GREAT LAKES INDIAN FISH AND WILDLIFE COMMISSION

July 8, 2012

Re: Application for permit 12-27-0001-P to impact Streams and Wetlands

Re: Copperwood Mine discharge from workings due to high head pressure

Figure 1. Head pressures in the Copperwood reflooded mine in relation to the box-cut portal and historical exploration borings.

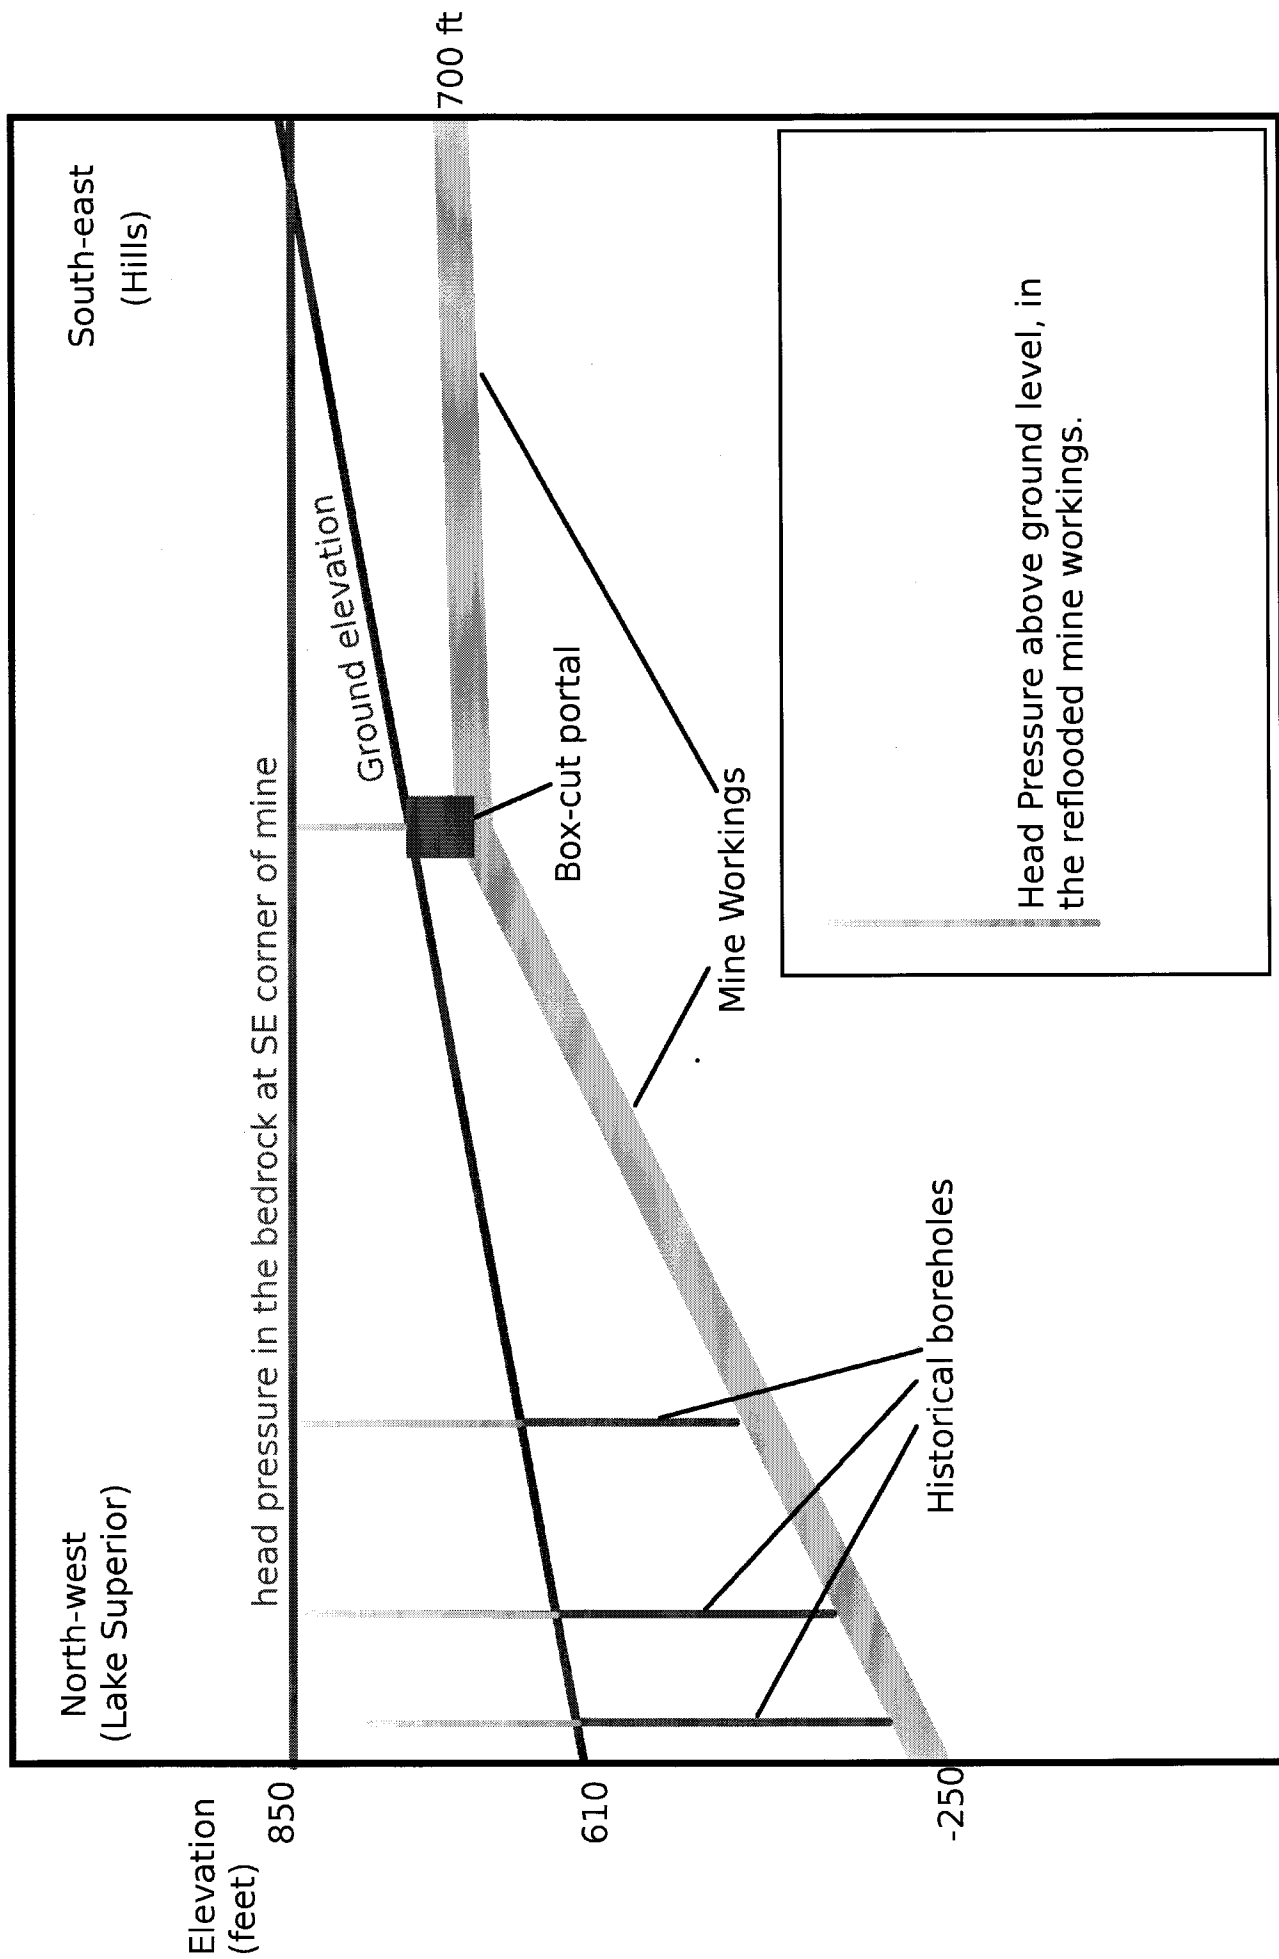
-The final head pressure in the reflooded, sealed mine workings will be approximately at an elevation of 850 feet, which is 240 feet above the ground surface in the north-west portion of the mine site.

-The excess head pressure in the reflooded mine of up to 240 feet above ground surface will tend to force brines in the lowest reaches of the mine up and out of the historical borings across the site, particularly in the north-west near Lake Superior.

-The excess head pressure in the reflooded mine at the box-cut portal will be 110 feet above ground surface (i.e. 850-740). This will tend to force water out of the portal area. It is unclear if proposed plugging of the portal is adequate to prevent discharge.

Appendix 202.5.2-2b: Ground Water Modeling SCENARIO #1 – Map View of Head Solution at the Bottom of the Nonesuch Shale (Layer 16) at the End of Stress Period #14 (21 Years After Dewatering); Contour Interval 25ft.

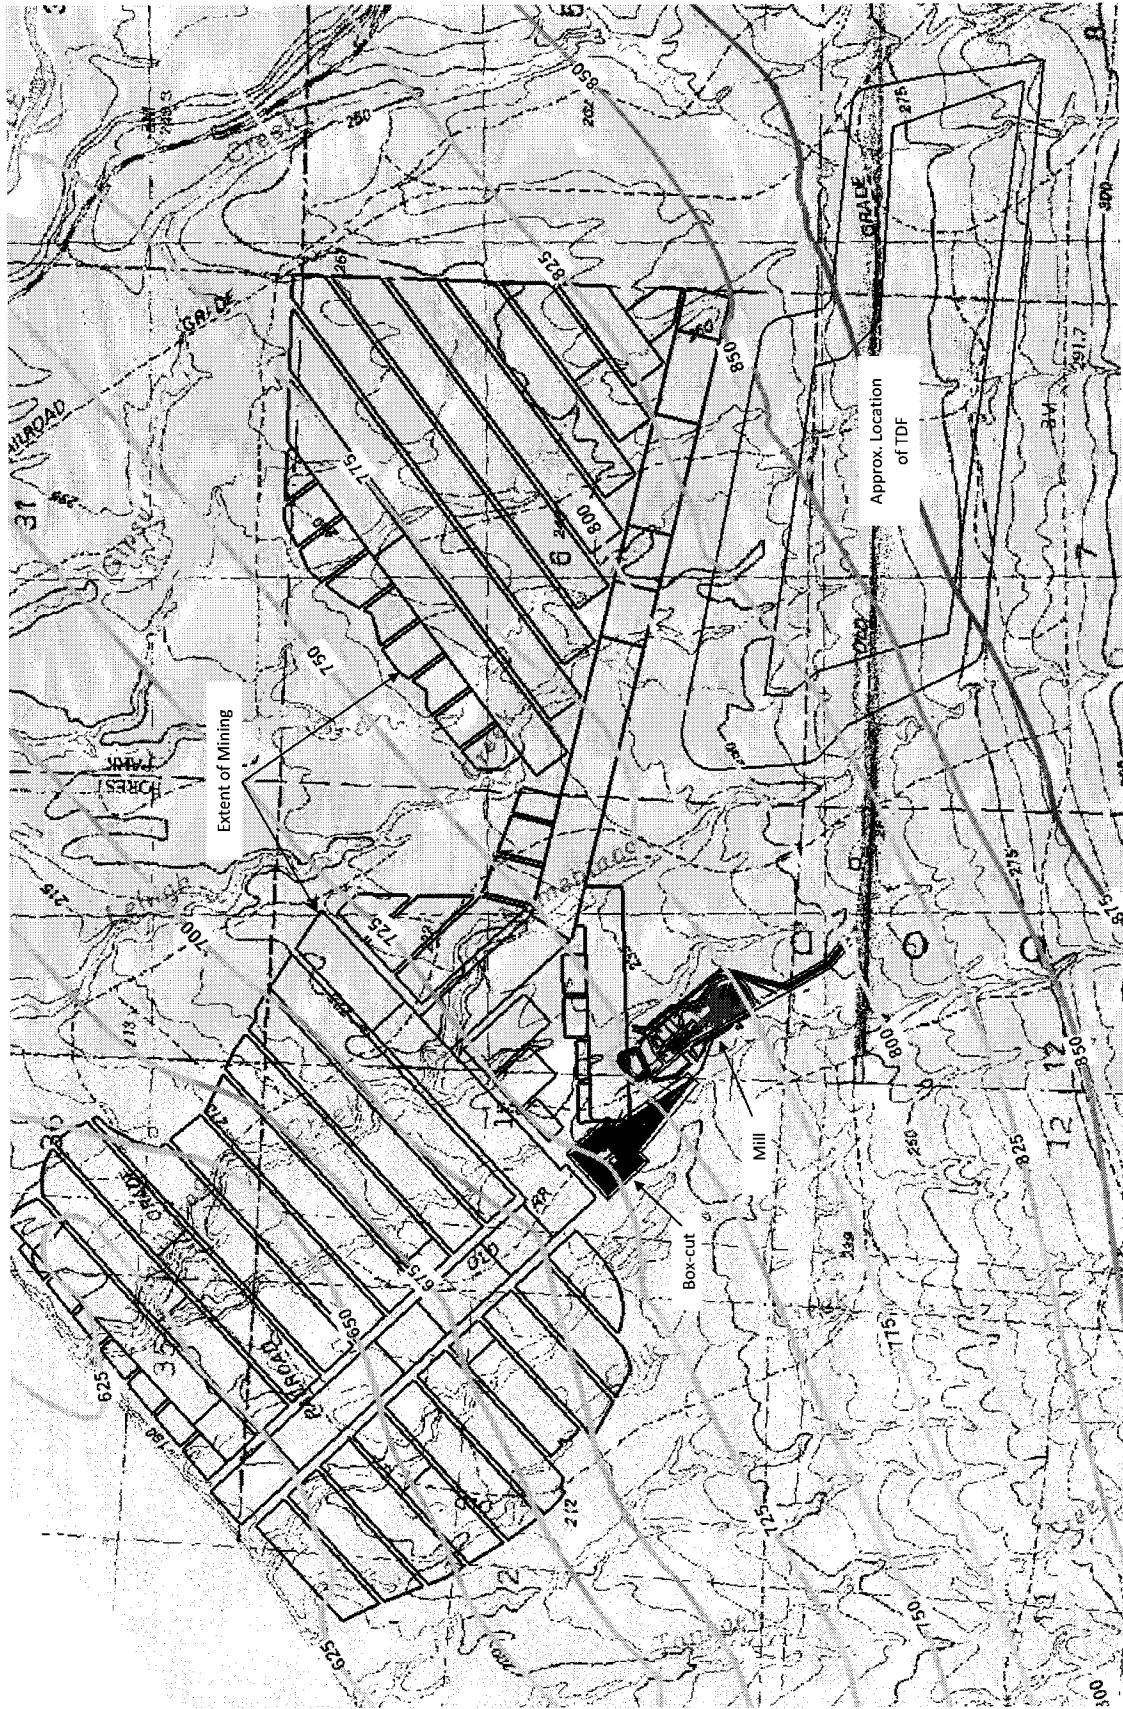
- Head in the bedrock aquifer surrounding the south-east corner of the reflooded mine is expected to be at an elevation of 850 feet (Orvana Responses, Appen_202.5.2-2b, attached).

-Natural inflow from the surrounding aquifer in the south-east portion of the mine workings will raise the head pressure in the mine to an elevation of approximately 850 feet.

Figure 16.30, Box Cut Location as shown in the PFS Report.

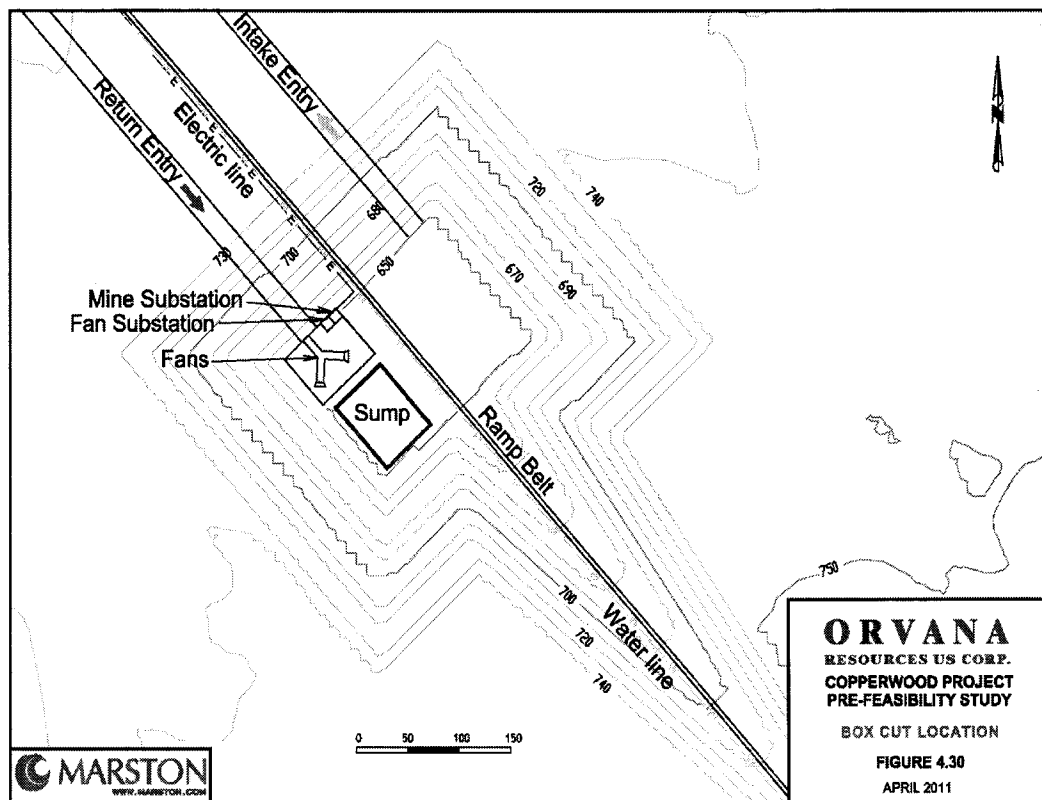
- The mouth of the box-cut portal is at an elevation of 650 feet and the land surface at the box-cut is at an elevation of 740 feet (MPA, Fig. 16.30, attached).

Drawn:	JWW	1/4/2012
Approved:	ARB	1/4/2012
Scale:	AS SHOWN	
PROJECT NUMBER	60179066	
FIGURE NUMBER	R-109B

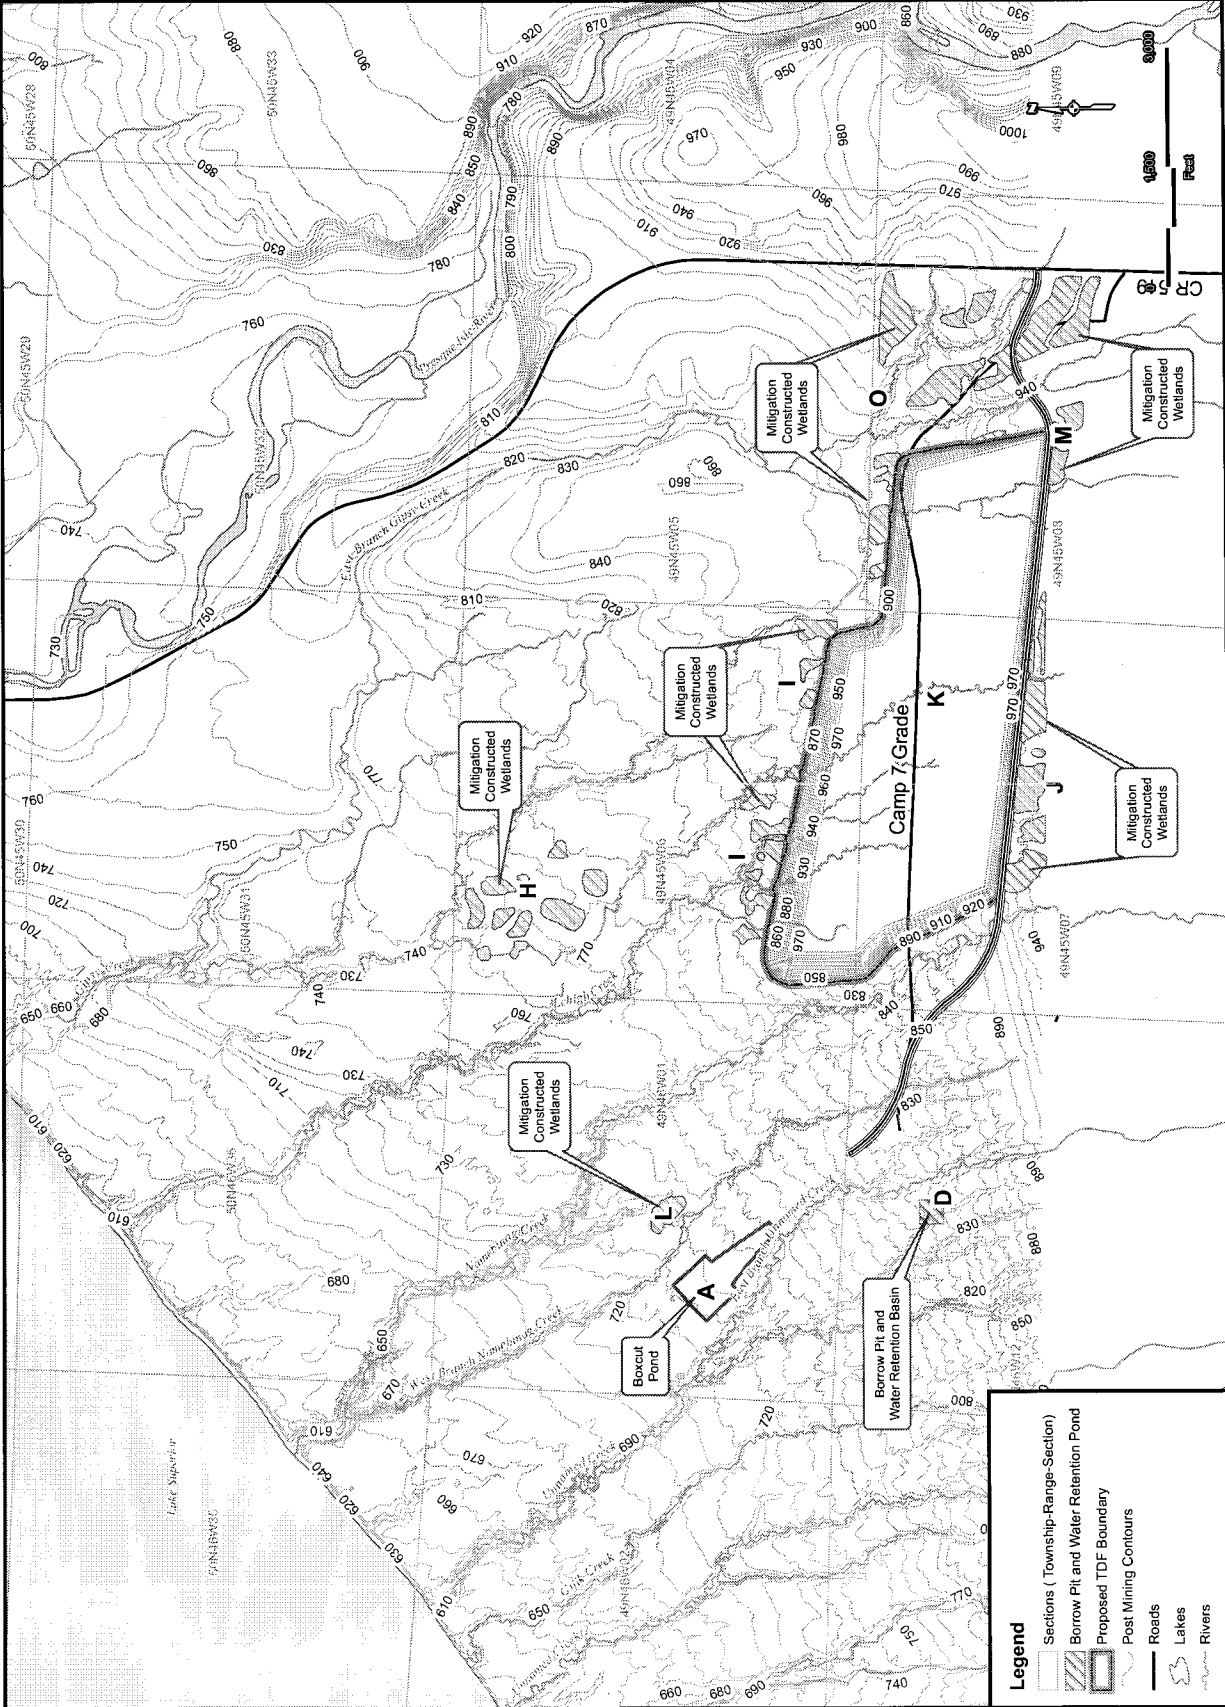
- The surface elevation at the north-west portion of the mine area is at an elevation of 620 feet (Orvana Responses, Fig. R-109B, attached).
- There were 161 holes drilled by USMR and 23 holed drilled by BCM in the 1950s in the area. (MPA, page 2).

Date: APRIL, 1995
Project: 461
File: XSECT-HH

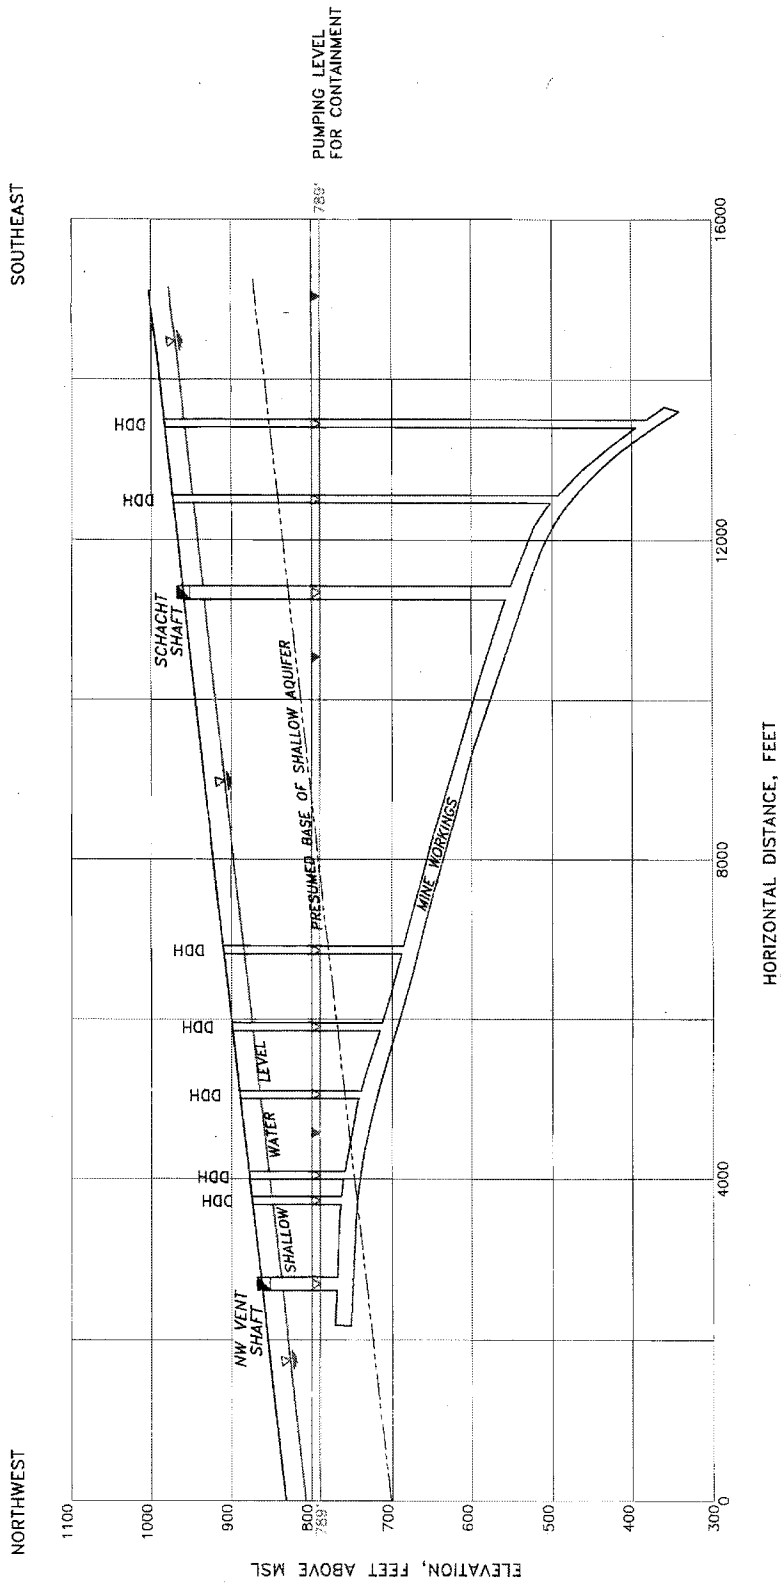
-The relationship of head in the reflooded mine water and brines at Orvana to the ground surface is likely to be similar to, but more extreme than, the relationship found at the White Pine Mine, where pumping is being used to prevent the escape of water/brines from the reflooded mine (Figure XSECT-HH, attached).
